METROPOLITAN GOVERNMENT OF NASHVILLE AND DAVIDSON COUNTY

STAFF RECOMMENDATION
1112 Lillian Street
January 15, 2014

Application: New construction - infill
District: Lockeland Springs-East End Neighborhood Conservation Zoning Overlay
Council District: 06
Map and Parcel Number: 08313013500
Applicant: Jeff Zeitlin, Martin Construction
Project Lead: Sean Alexander, sean.alexander@nashville.gov

GRADING SITE PLAN
1112 LILLIAN STREET
A HORIZONTAL PROPERTY REGIME
WITH PRIVATE ELEMENTS

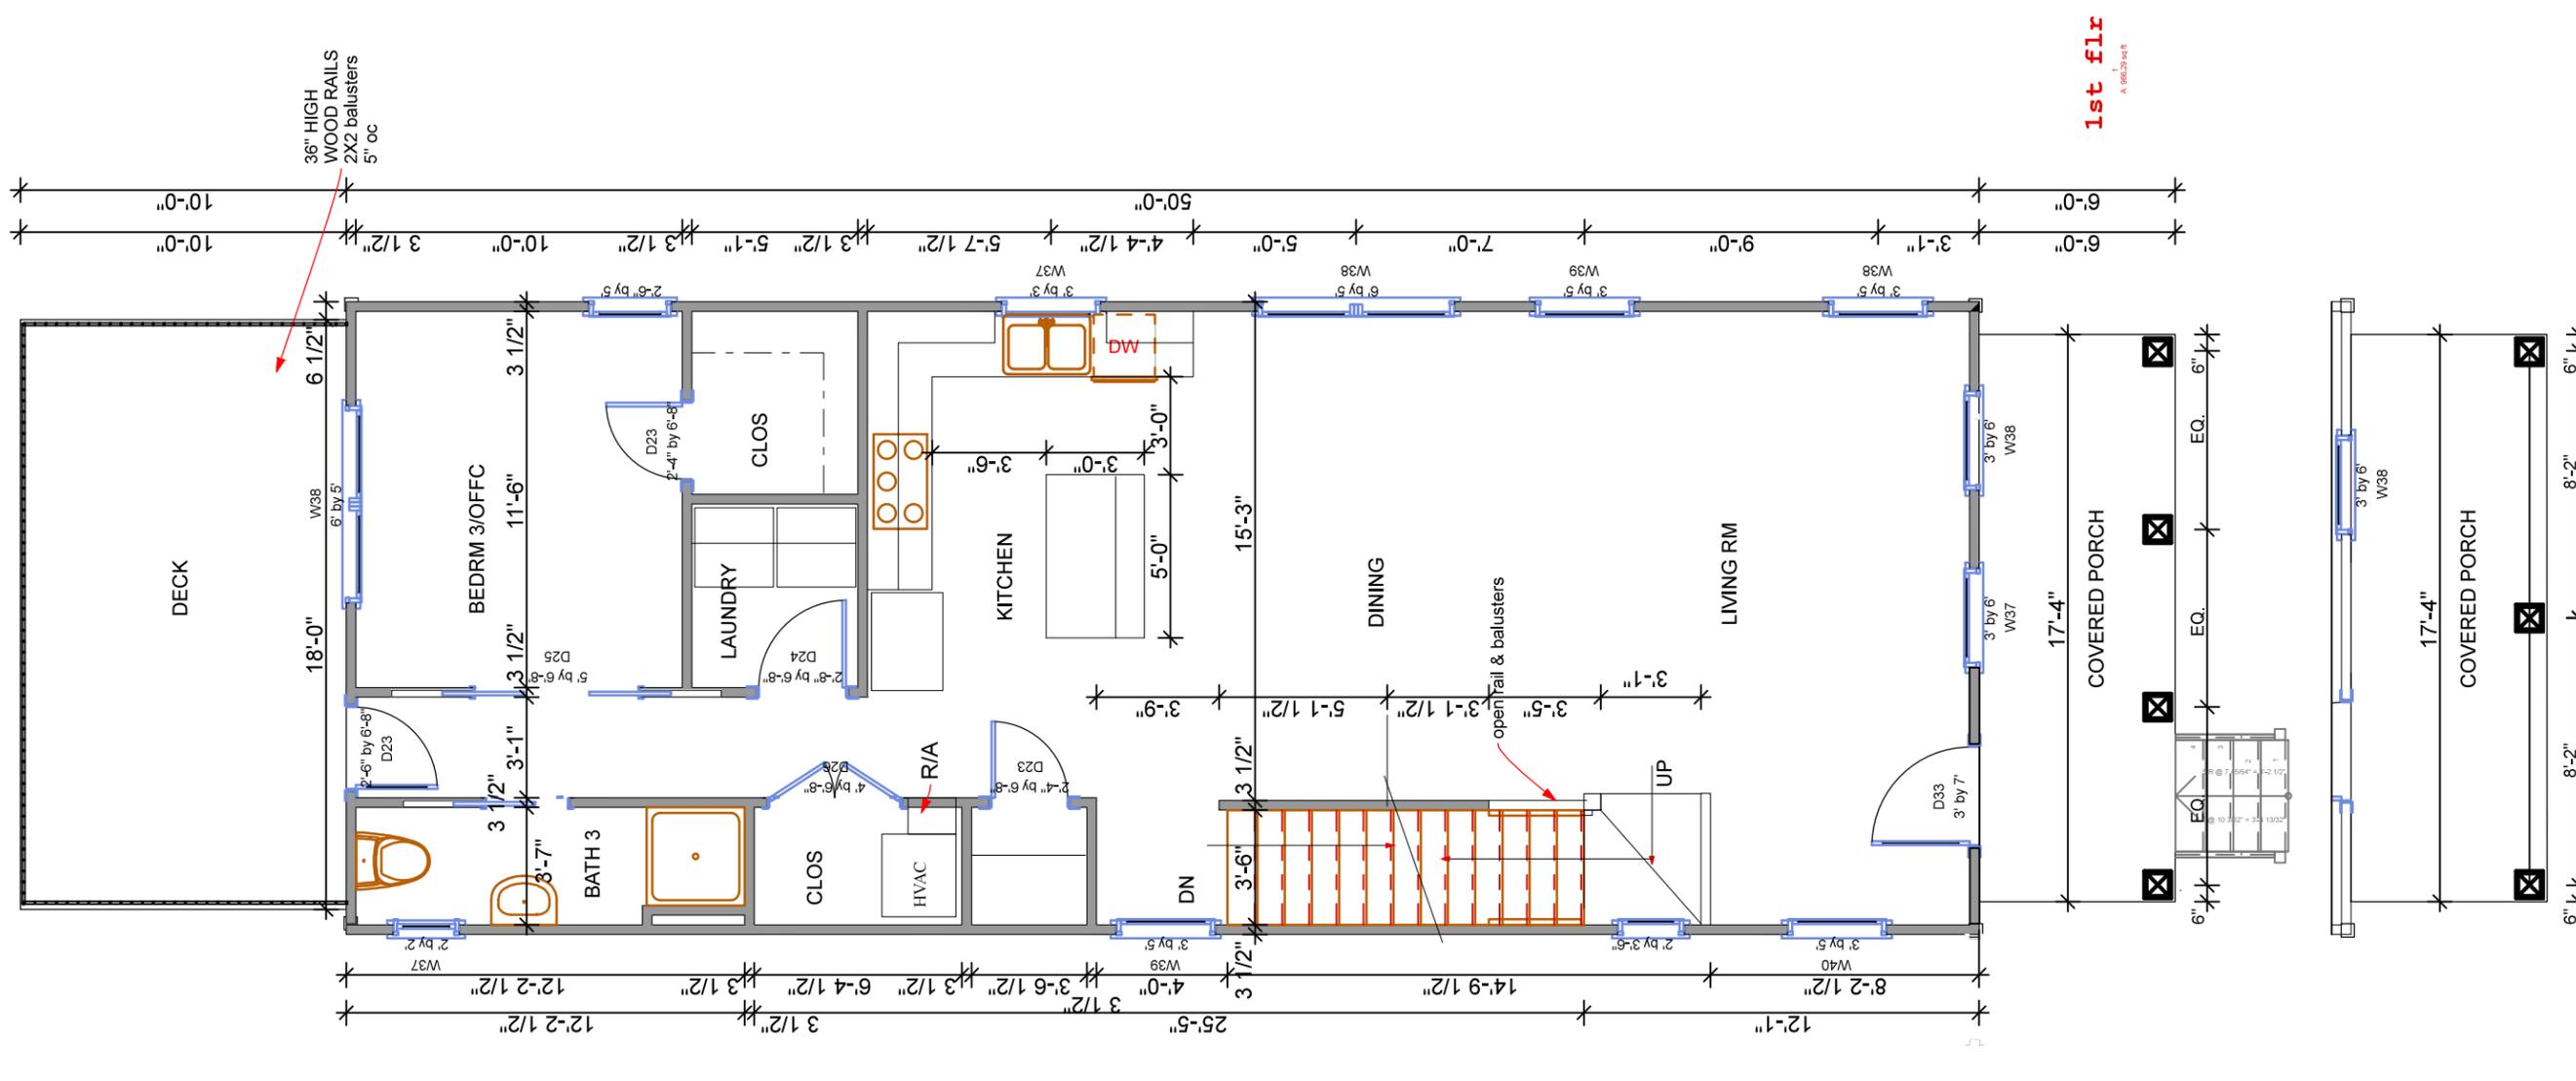
The front of the building will be located with the front edge in line with adjacent structures, between eighteen and twenty feet (18' - 20') from the street, which is an appropriate setback. The building's side setbacks will be approximately six feet, six inches (6'-6") on each side. Although this meets bulk zoning requirements the width and resulting side setbacks do not match the rhythm of the street, as seen in the areas of historic context.

Also, by widening the structure to the maximum allowed under the current setback regulations, the interior of the structure would be increased by nearly two hundred square feet (200 sf) per level.

Furthermore, this lot and a similarly narrow lot adjacent at 1114 Lillian Street are being developed by the same applicant. Because of the narrowness of these lots it may be possible to reduce the required setbacks from the shared property line between them, allowing the infill to be even wider and therefore making a one and one-half story building that much more feasible.

Basement Plan
1/4" = 1'-0"

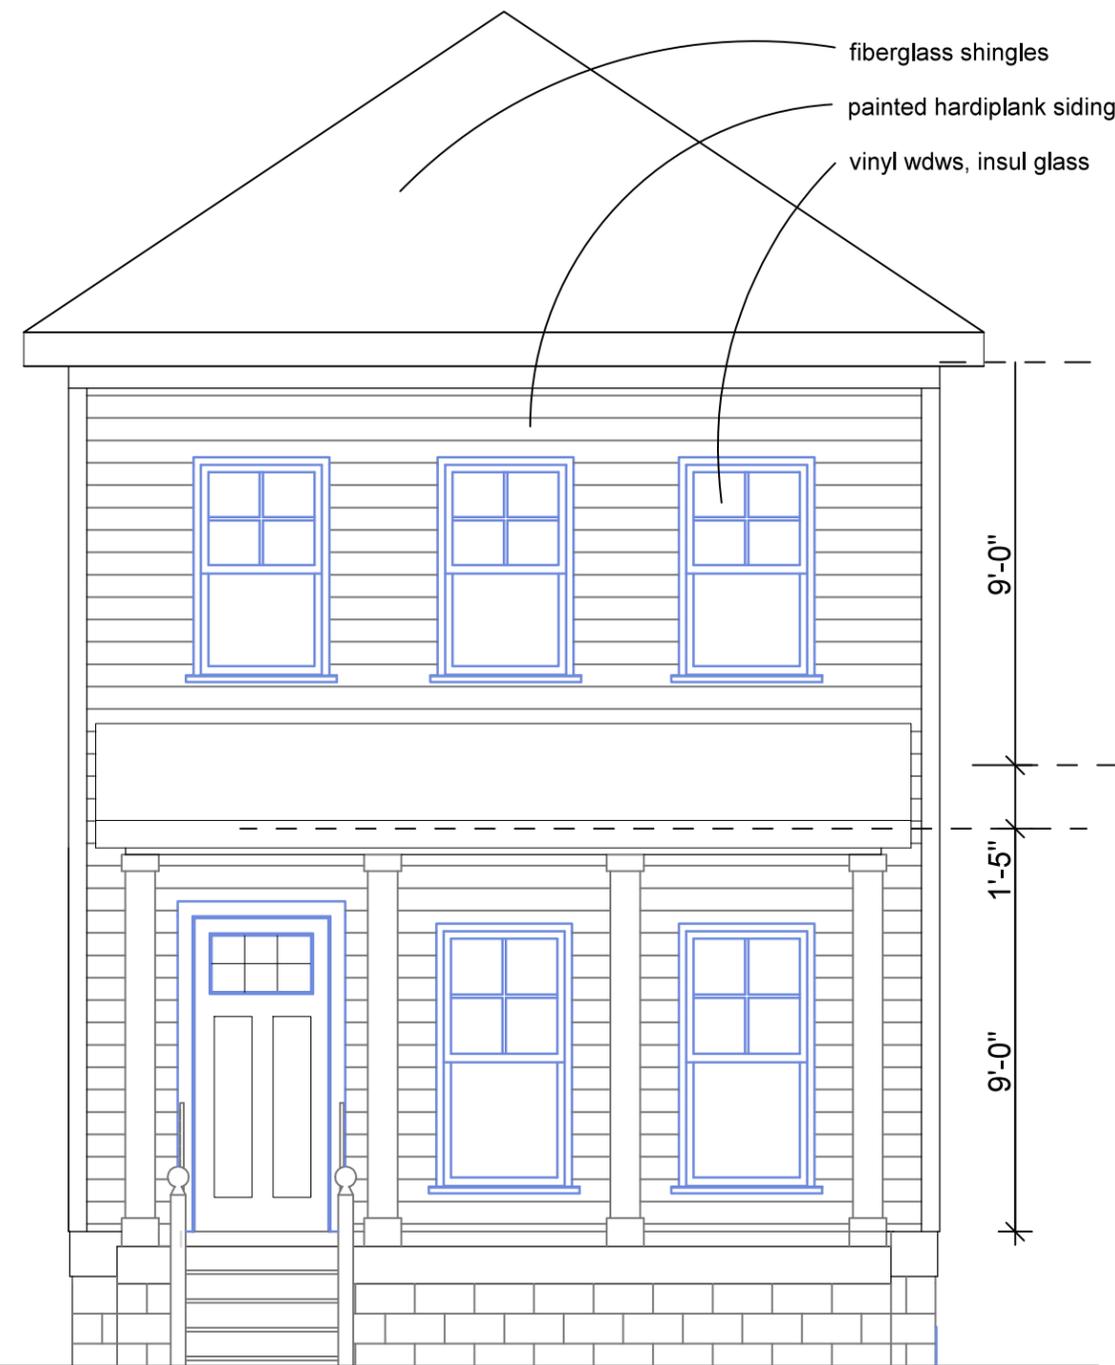
The new building would have a two-car garage in the basement, accessed by a driveway from the rear alley. The Commission has approved rear-accessed garages in basements when they are in the typical location of historic outbuildings. Staff finds that the project meets section II.B.8 of the design guidelines.

Firstly, the current proposal would have a five hundred square foot (500 sf) garage in the basement level of the house. Staff has recommended that the garage be separated from the house and placed at the rear of the lot. The exposed basement area could then be more efficiently used as living space, reducing the amount of living space that would need to be in the upperstory. This would also be more appropriate because historically garages would have been detached and located at the rear of a lot.

FRONT ELEVATIONS

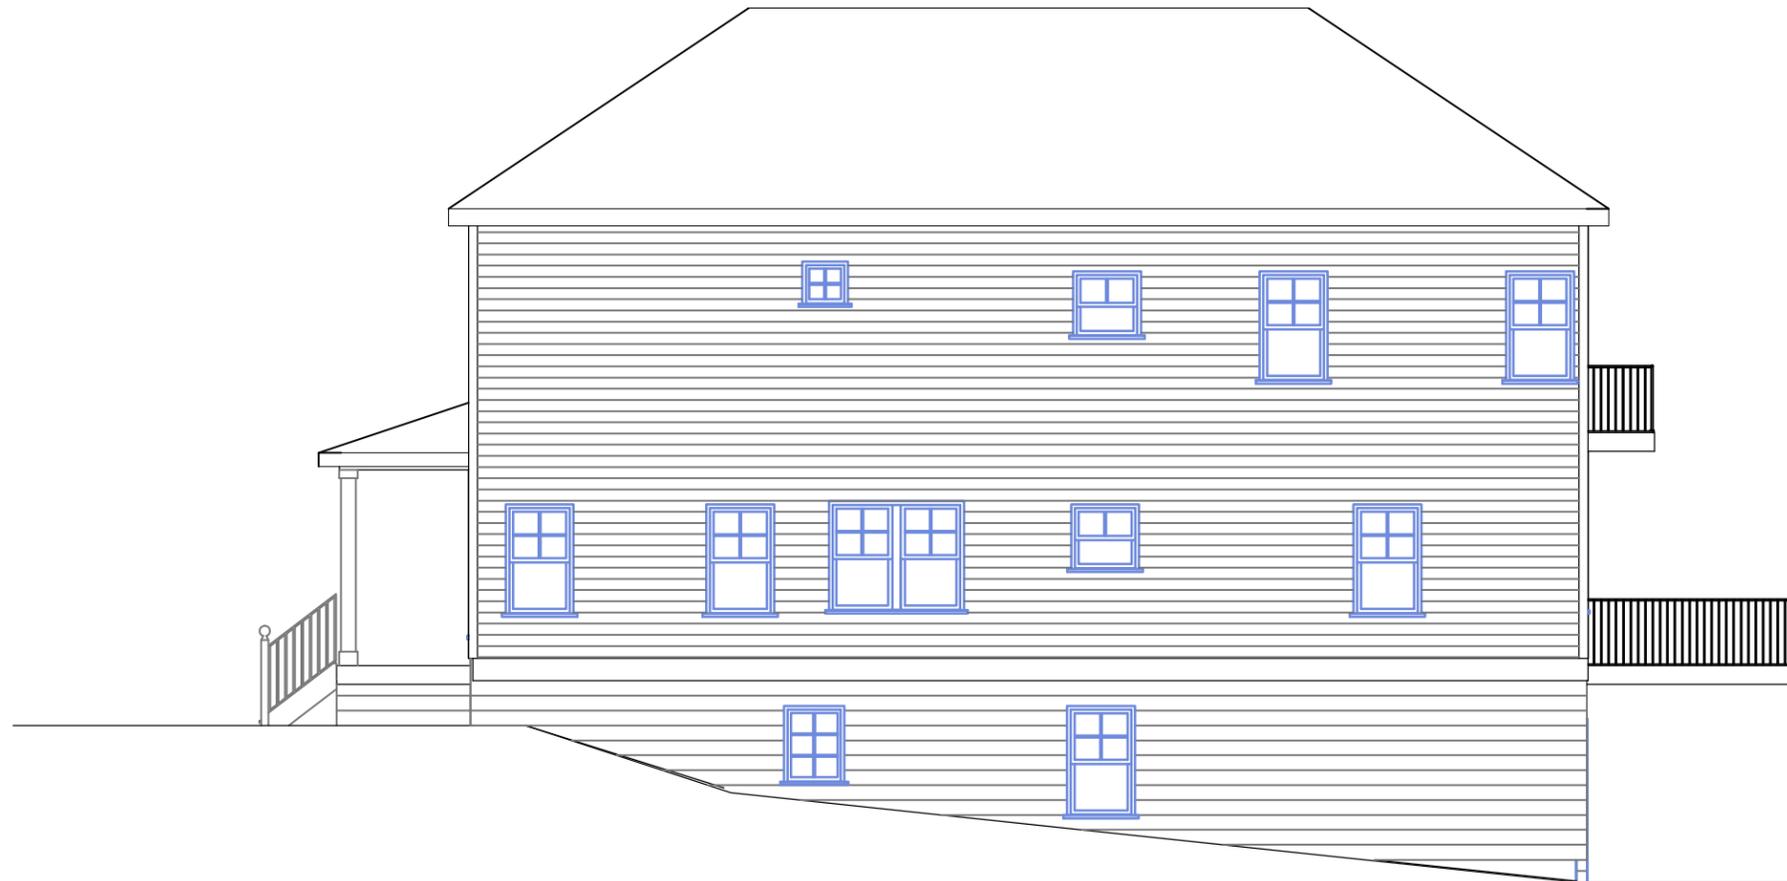
The new building will be two-stories tall with the peak of the roof at thirty-two feet (32') and eaves at twenty-two feet (22') above grade at the front. By comparison, the existing houses on Lillian Street range between thirteen feet (13') and twenty feet (20'). There will be two feet (2') of foundation exposed and a one foot (1') water-table band between the foundation and the finished floor level. Due to a drop in grade, the structure will gain an additional story in the basement level at the rear. The plans show the basement-level as having a bedroom, a bathroom, and a two-car garage.

Staff finds that the height and scale of the proposed two story house would not be compatible with surrounding buildings and would not meet guidelines II.B.1 and II.B.2.

The front elevation will have three evenly-spaced bays on each story, which is compatible with the proportion and rhythm of openings on historic houses. The windows on the side elevations would be more irregular in their proportions and rhythm of placement. Additionally, both side elevations would have incompatibly large expanses of wall space without any openings. Staff finds the project's proportion and rhythm of openings would not meet guideline II.B.7.

A one and one-half story structure with dormers creating a usable second level would be more compatible with the surrounding context. Recognizing that the narrowness of the lot creates challenges for any new construction, staff has discussed possible revisions that would help the project better meet the design guidelines.
